LACKEY #8 CHACRA

UNIT M SECTION 27 T28N R09W San Juan County, New Mexico P & A Procedure

Re: Permanent Abandonment

Well: 8 Lackey

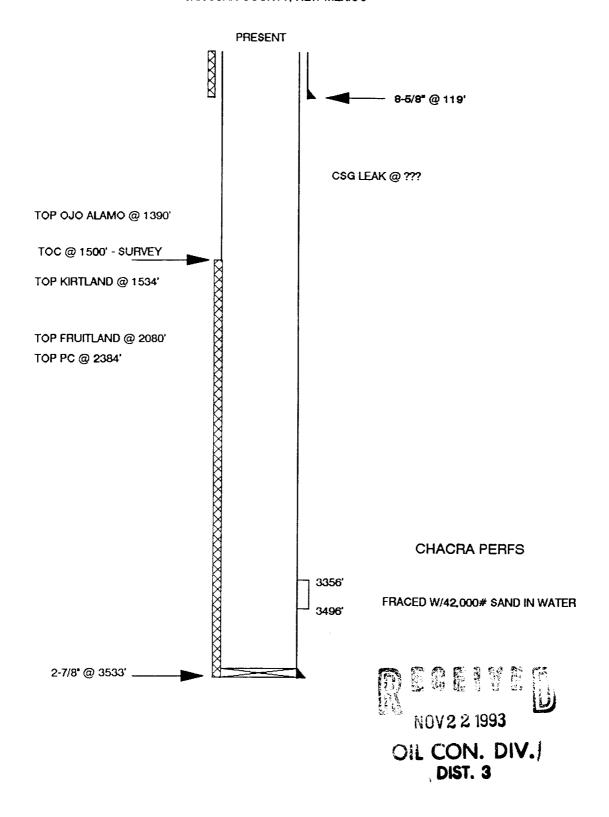
1.) It cement does <u>Not</u> circulate out the busdenhad from 1750', perforte 2277' and circulate cement to the Surface, (Nacimiento Top 2227')

1a) It coment circulates out the broden head from 1950', spot a coment pluy inside the casing from 277' to the surface.
